Change Notification Number: 1226

Change Title: Product range update

Affected Products:

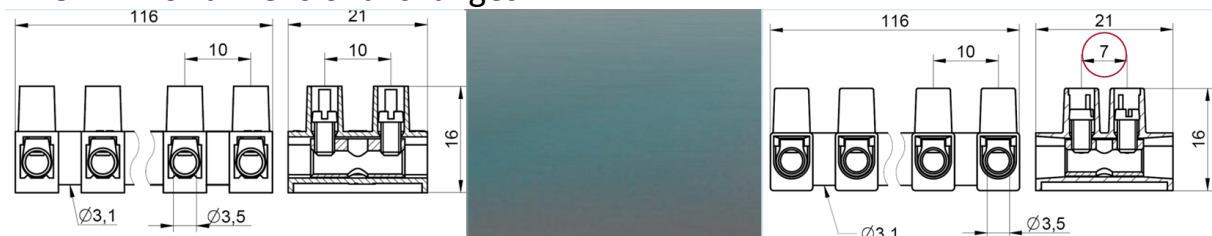
Due to a tooling upgrade the above mentioned products will feature:

1. Guided wire entries - moulding fits the shape of the metal inserts preventing wires from straying outside the inserts.

2. A higher purity polyamide will be used. This has a more transparent look and will result in no sharp edges

3. Minor dimensional changes:

4. CTSN633 only – maximum temperature is to be reduced from 180°C to 160°C
